## ALERT SERVICE BULLETIN

**505-25-43**

**SUBJECT:** CREW SEAT RESTRAINT ROTARY BUCKLE ASSEMBLY 1111475-01, ONE-TIME INSPECTION OF.

## SB 1111475-25-001-2023

**Figure 1**  
*PNR 1111475 Series Rotary Buckle and Broken Screw Head*

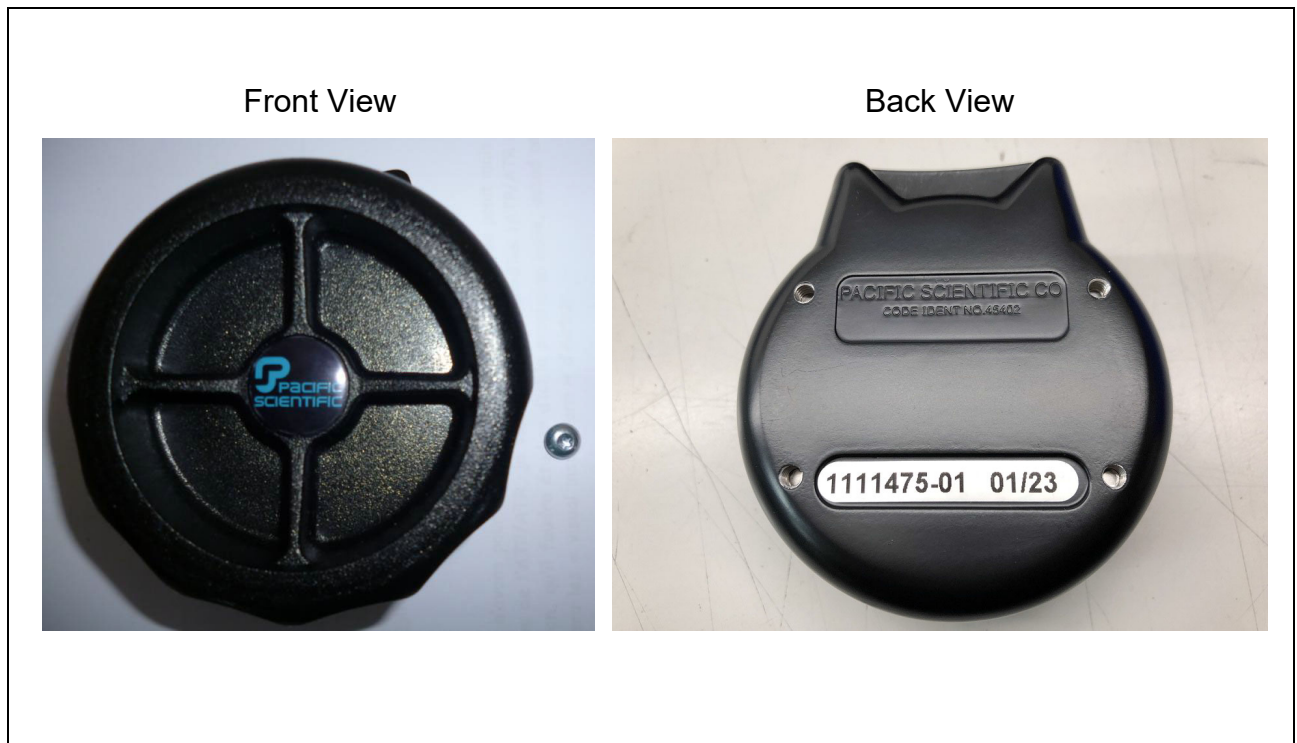
- (1) In 2012 a specific lot of PNR 0901101-123 screws were improperly zinc chromate plated. This manufacturing issue resulted in the screws becoming brittle. Evidence has shown that the screw heads can break-off under load creating an unsafe condition and improper function of the rotary buckle used on the restraint system.
- (2) Screws (PNR 0901101-123) used on rotary buckles (PNR 1111475 Series) are susceptible to premature failure of the screw.
- (3) Parker Meggitt has received field reports of cracked and missing screw heads. Figure 1 on page 7 shows an example of a PNR 1111475 Series buckle with a broken screw head.

**Figure 2**  
*Flowchart of Required Operator Action*

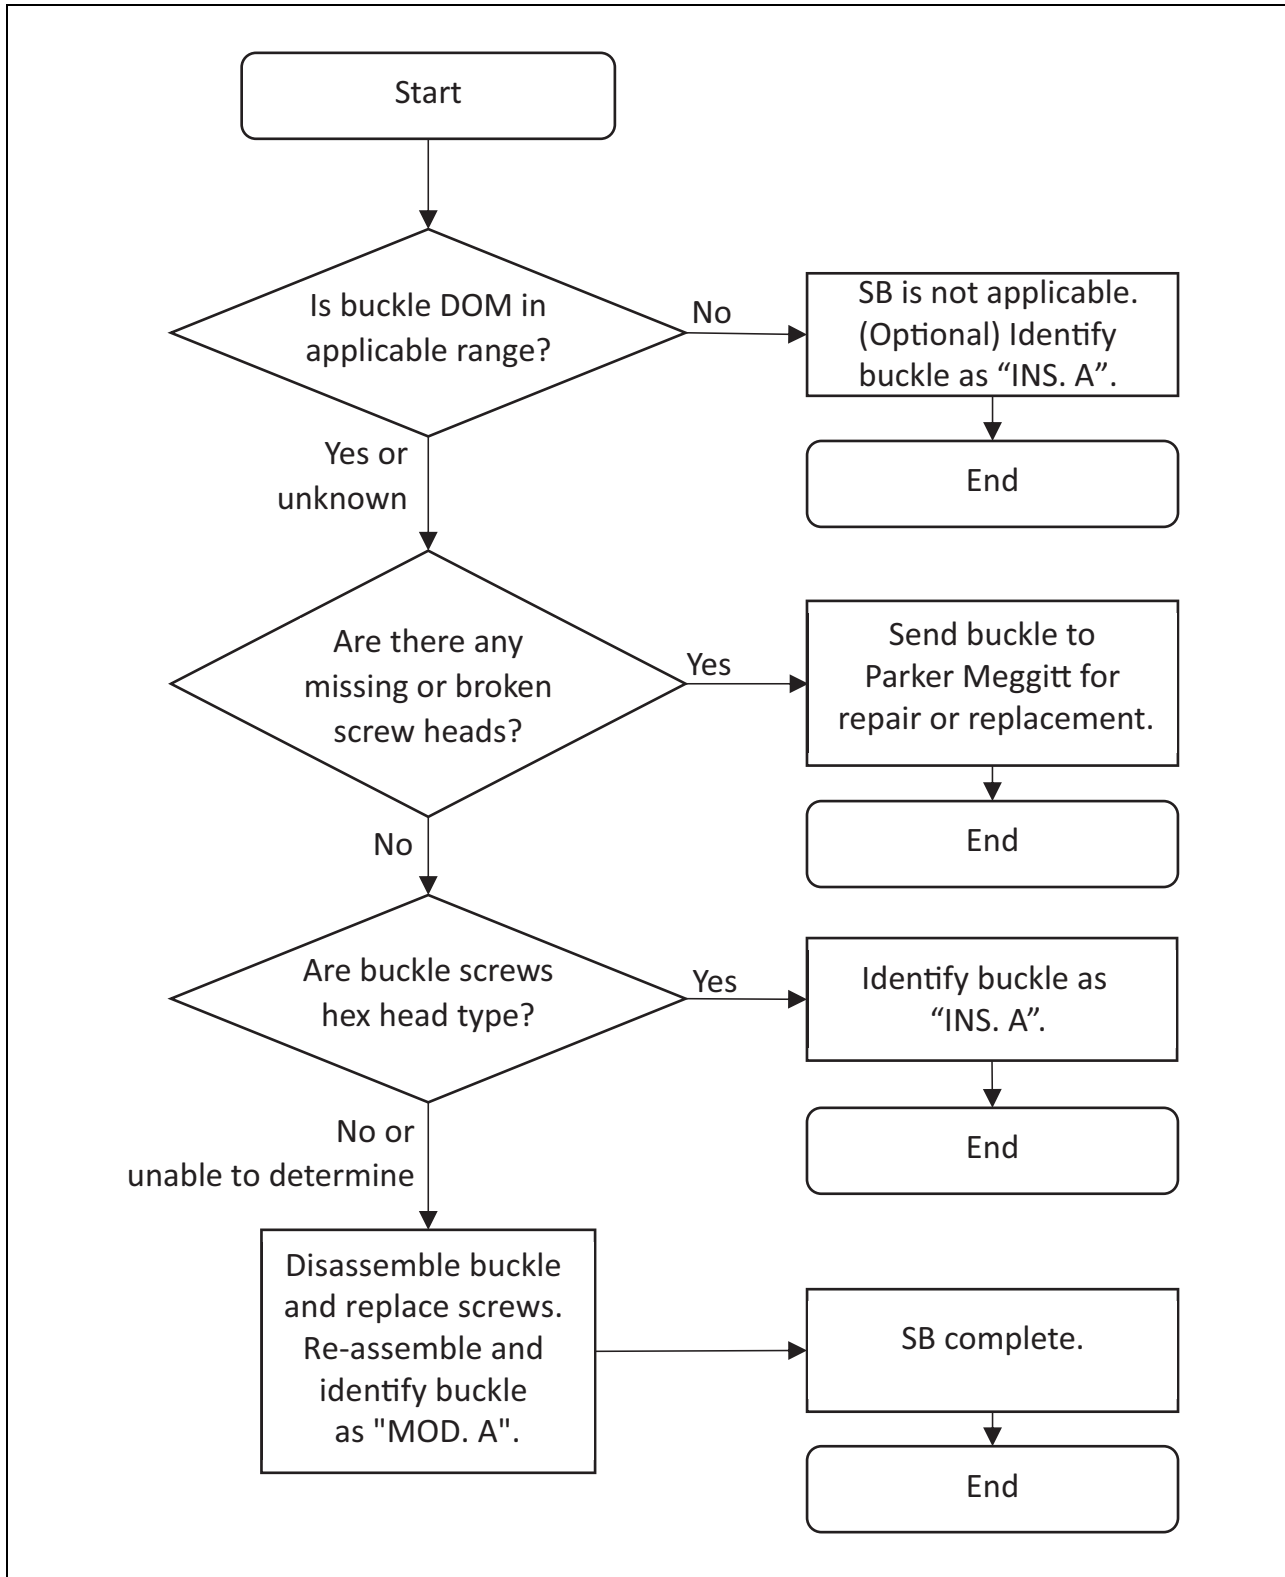
- (a) Refer to the flowchart in Figure 2 on page 10.
- (b) Operators should check all restraint systems and buckle assemblies in service and inventory that meet the criteria in sections 1.A. & 1.B. This also applies to restraint systems in storage or any restraint system that may have had a buckle replaced with one of these part numbers, or that may have been repaired using the suspect screws.

**Figure 3**  
*PNR 1111475 Series Rotary Buckle Screw Location*

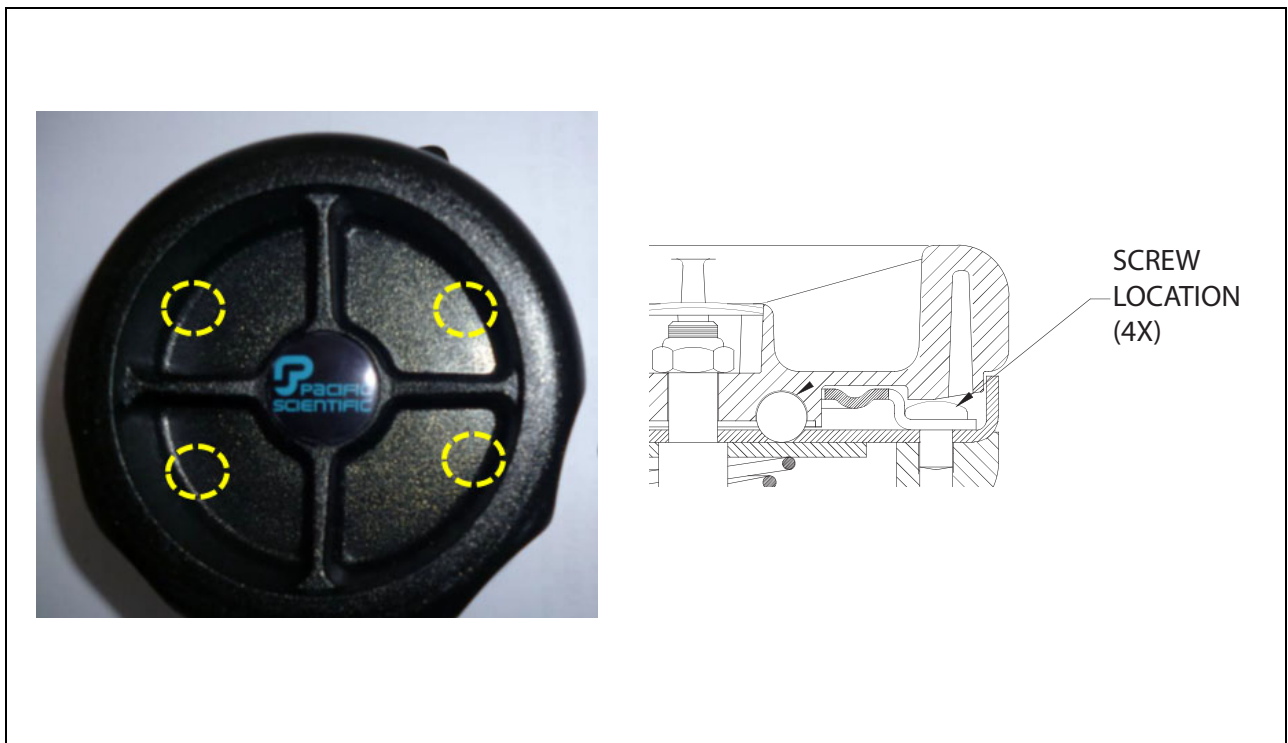
- (1) Use an inspection light to look through the belt openings in the rotary buckle. Refer to Figure 3 and Figure 4 on page 16 to locate the screws.
- (2) Inspect for the presence of 2 screw heads each on the left side and the right side of the buckle. Refer to Figure 5 on page 16.

**Figure 6**  
*Magnet Test on PNR 1111475 Series Rotary Buckle with Velcro*

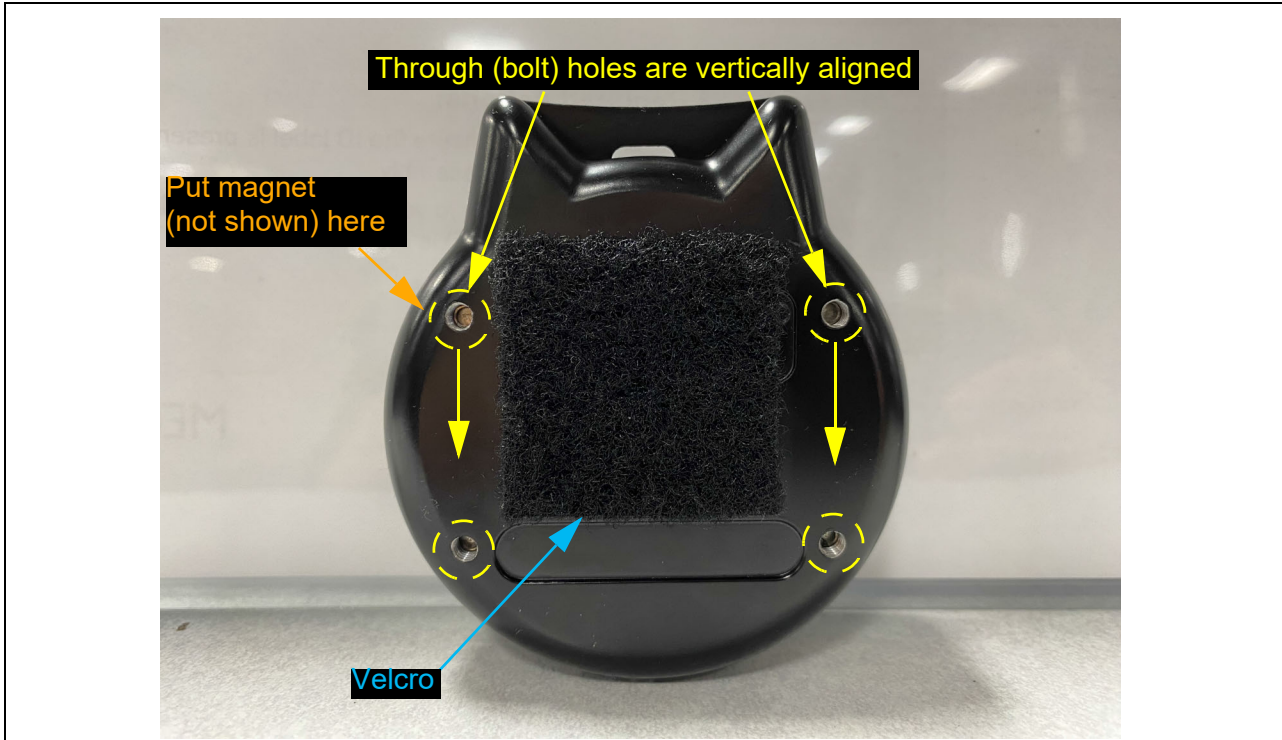
- b If the rotary buckle does have Velcro attached as shown in Figure 6 on page 18, hold the rotary buckle such that the through (bolt) holes align vertically, one directly above the other.

- 3 Put a magnet against the buckle back in the circled yellow area in Figure 6 on page 18 or Figure 7 on page 18 and release the magnet.
- 4 Repeat 2 and 3 for the other 3 through (bolt) holes.

**Figure 7**  
*Magnet Test on PNR 1111475 Series Rotary Buckle*

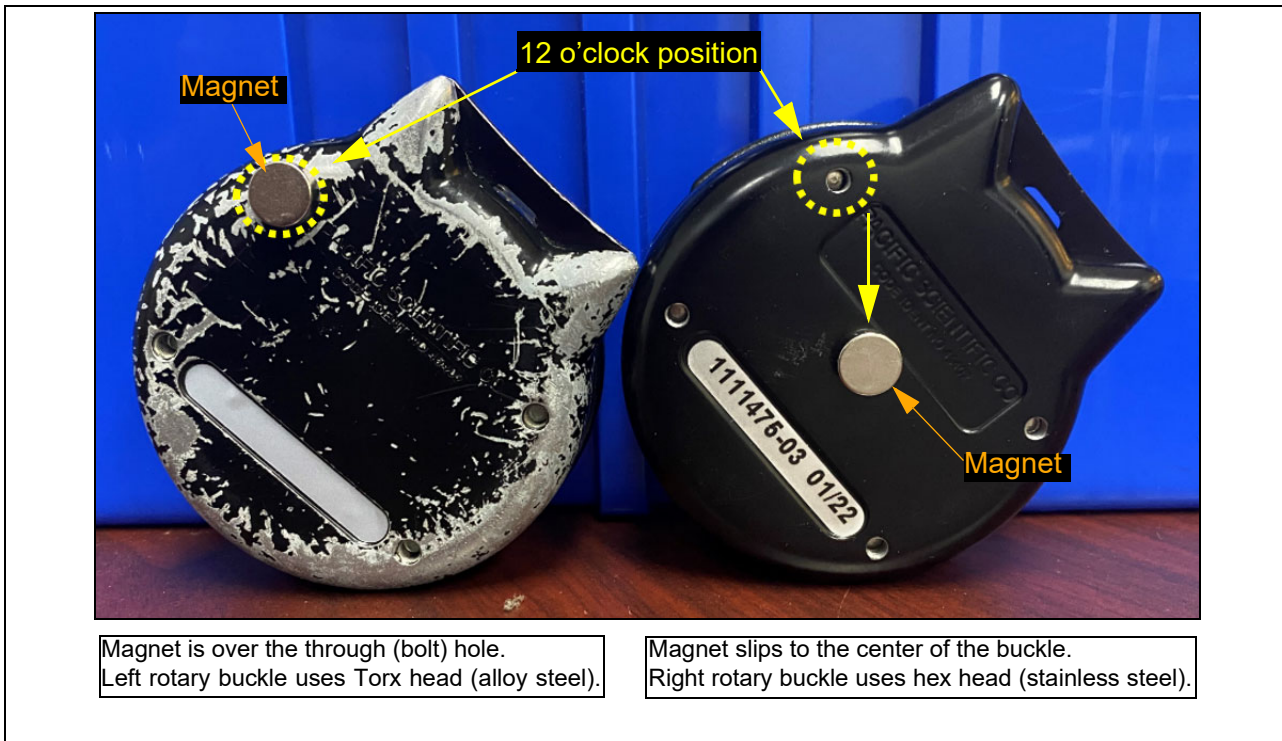
- 5 Interpret results for each of the following :
  - a If the magnet stays in place over the through (bolt) hole, this shows that the buckle has the Torx head (alloy steel) screws installed. The buckle WILL need the screws replaced. An example of this is shown in the left image of Figure 7 on page 18.

- b If the magnet slips down to and stops at the center of the buckle, this shows that the buckle has the hex head (stainless steel) screws. The buckle will NOT need the screw replaced. An example of this is shown in the right image of Figure 7 on page 18.

**Figure 11**  
*Removal of Rotary Buckle*

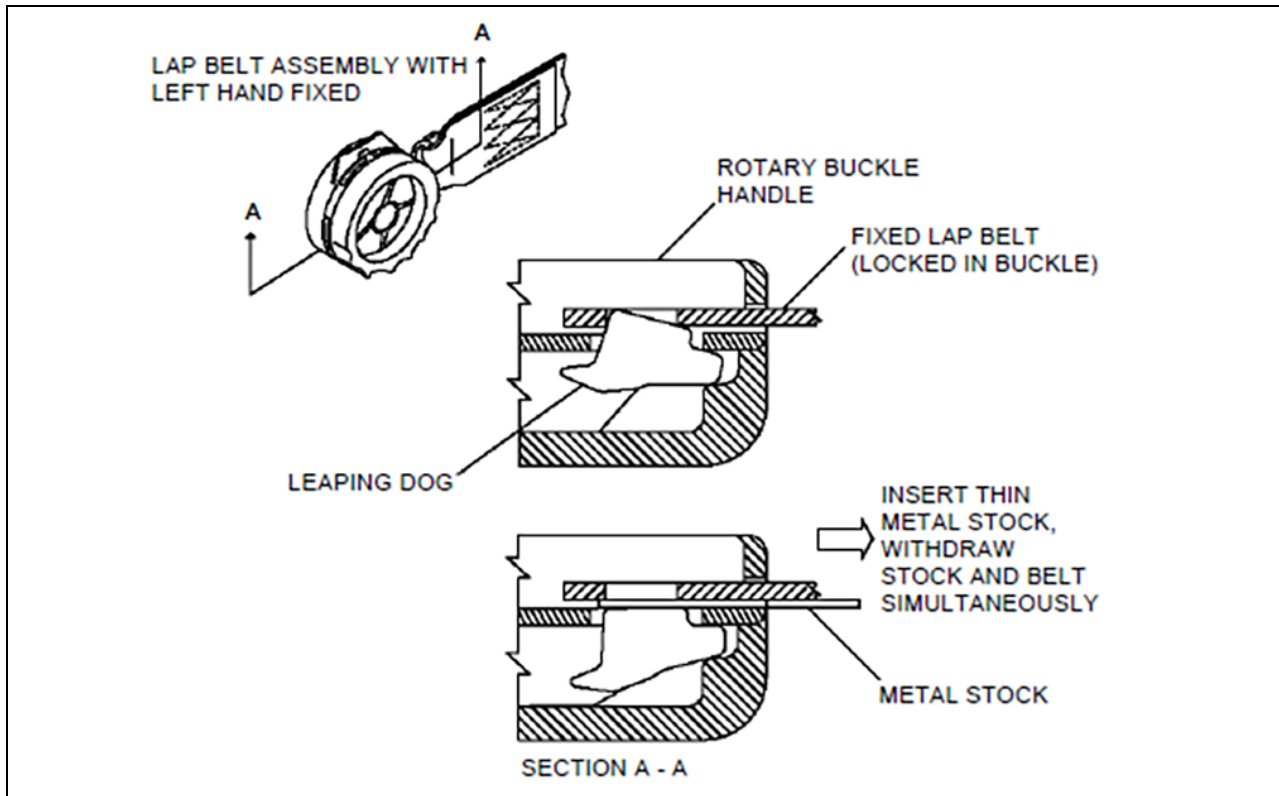
- (2) Refer to Figure 11.
- (3) Insert a piece of thin metal stock or shim into the slot of the rotary buckle and push inward between the fitting and the buckle locking mechanism.
- (4) Pull the fitting from the buckle.
